from
**Southern
Water**

Your ref
BN/147/21/OUT

Proposal: Outline application with all matters reserved (except access) for the erection of up to 8 No. dwellings. This application also lies within the parish of Aldingbourne.

Site: BN/147/21/OUT: - Land West of Fontwell Avenue, Fontwell, Eastergate, PO20 3RX.

SOUTHERN WATER

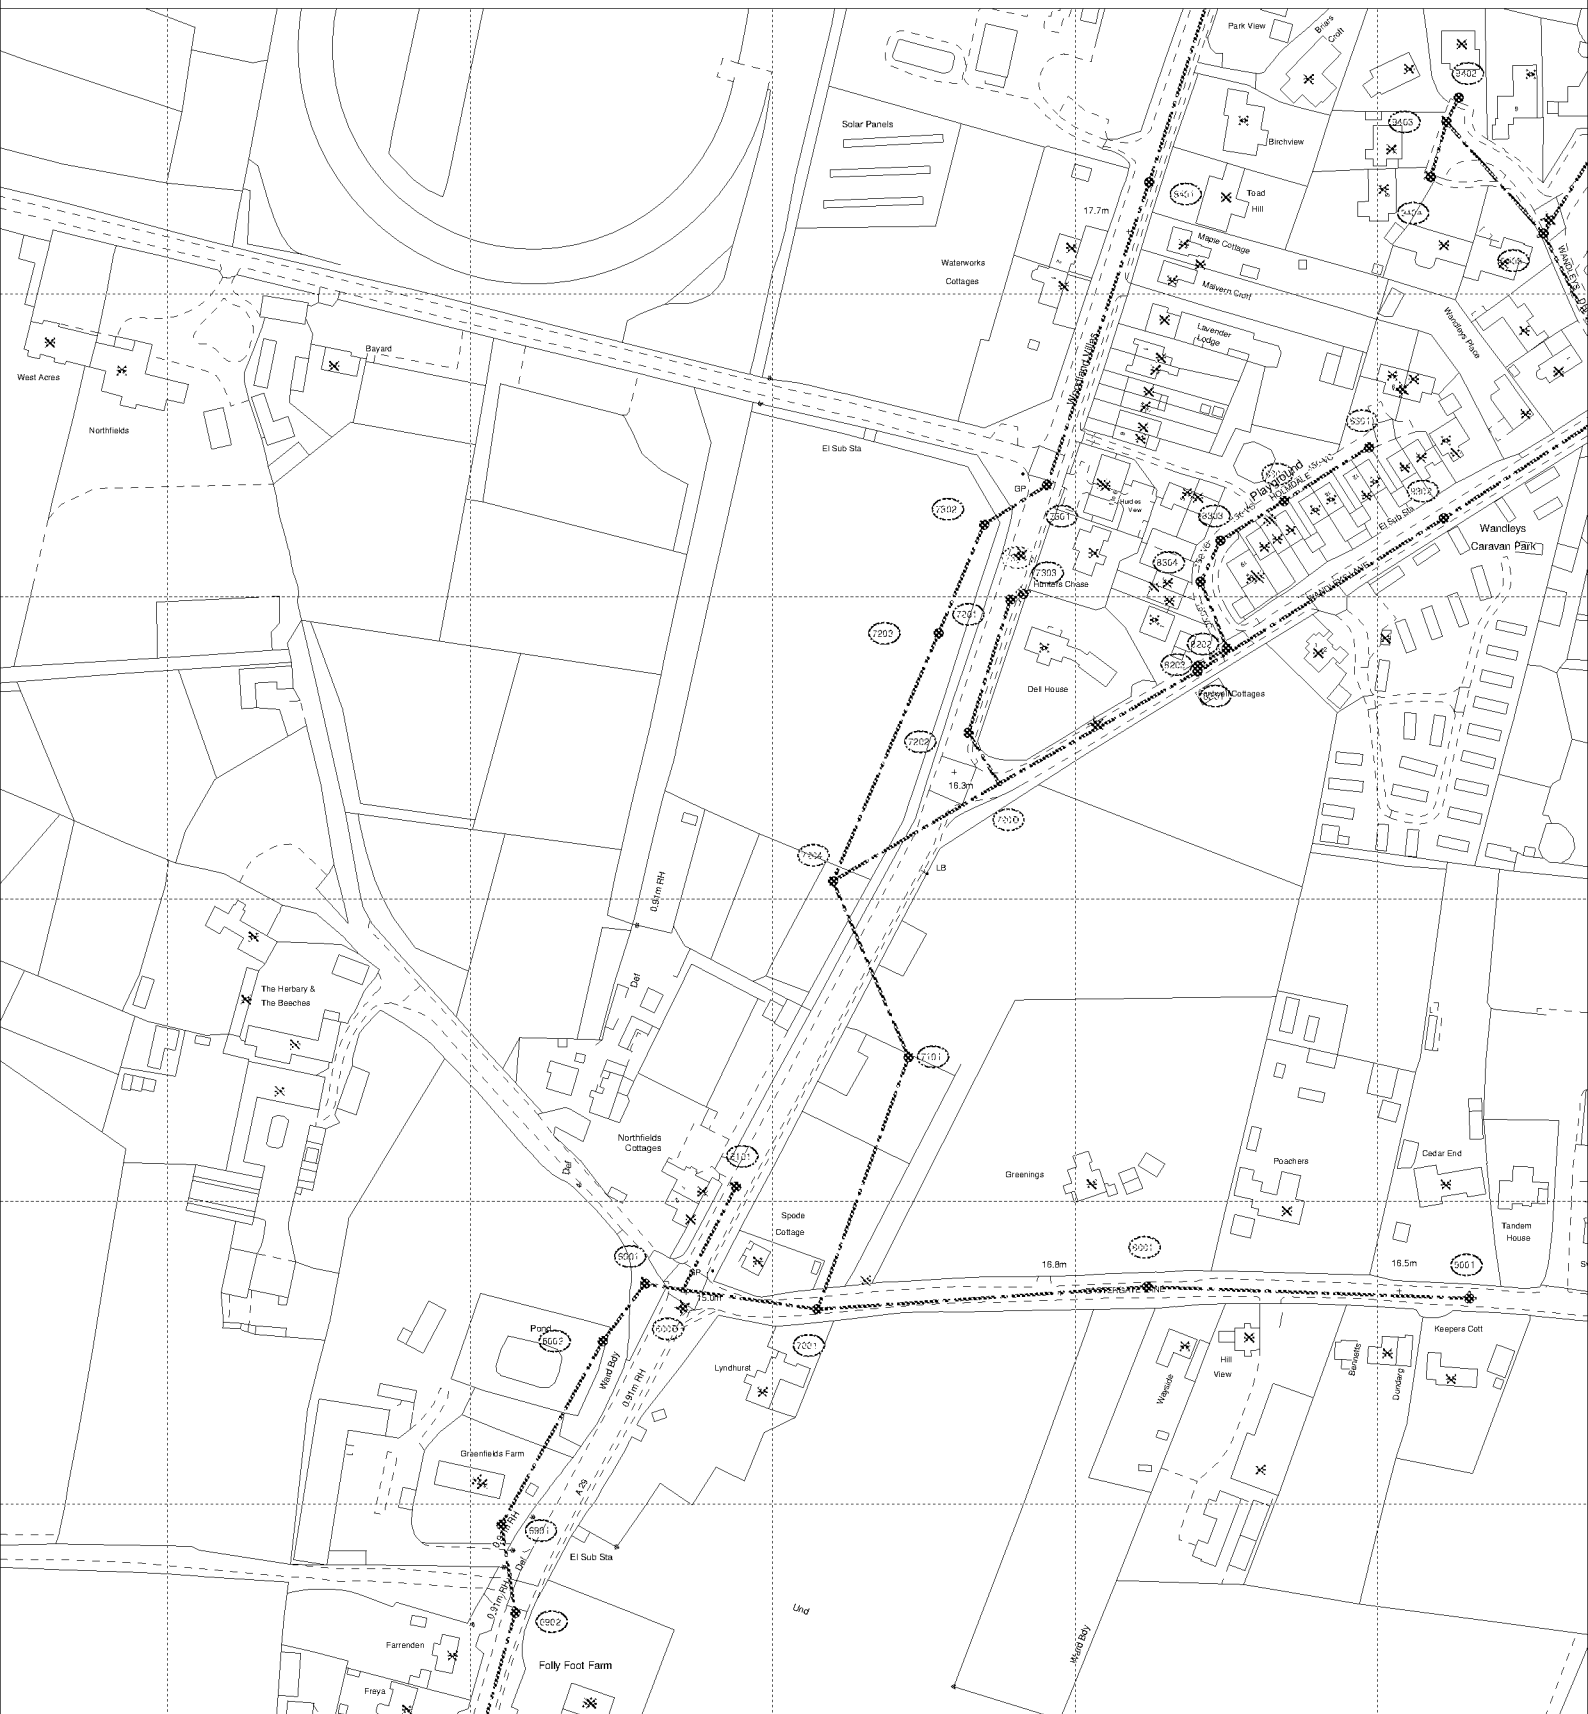
Please see the attached extract from Southern Water records showing the approximate position of our existing foul sewer within access of the development site. The exact position of the public asset must be determined on site by the applicant in consultation with Southern Water before the layout of the proposed development is finalised.

- The 225 mm diameter gravity sewer requires a clearance of 3 metres on either side of the gravity sewer to protect it from construction works and to allow for future maintenance access.
- No development or tree planting should be carried out within 3 metres of the external edge of the public gravity sewer without consent from Southern Water.
- No soakaways, swales, ponds, watercourses or any other surface water retaining or conveying features should be located within 5 metres of public or adoptable gravity sewers.
- All existing infrastructure should be protected during the course of construction works.
